Staff Report
City of Richmond, Virginia
Planning Commission

UDC 2022-24	Final Review	Meeting Date: 12/5/2022
Applicant/Petitioner	Bill Boston – Department of Public Utilities, Stormwater	
Project Description	FINAL location, character, and extent review of the Greening Greater Fulton project	
Project Location		
Address: ROW for 4900 and 5000 blocks of Government Road		
Property Owner: City of Richmond/ Adjacent Commercial Properties		
High-Level Details: Innovate Fulton, the Alliance for the Chesapeake Bay, and Groundwork RVA have partnered together to create a concept plan for stormwater retention infrastructure and environmentally sustainable streetscape improvements along Government Road between Williamsburg Road and Carlisle Avenue. The project will include permeable pavement, street trees, rain gardens, a small pedestrian plaza, and a public art installation. The project will enhance the pedestrian experience; further many citywide sustainability and environmental goals; increase business attraction; and provide important investment in transportation and green infrastructure in an area that is historically underinvested and low income.

TREE LAWN AT JUNCTION

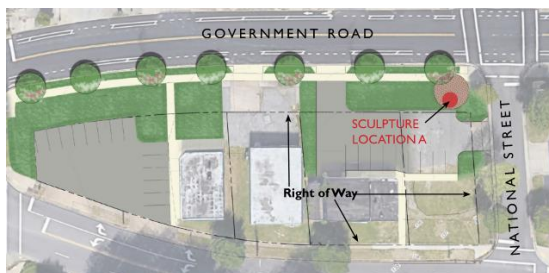
A continuous tree lawn is proposed between the sidewalk and street curb, rather than smaller and more confined tree wells, which will facilitate greater tree health.
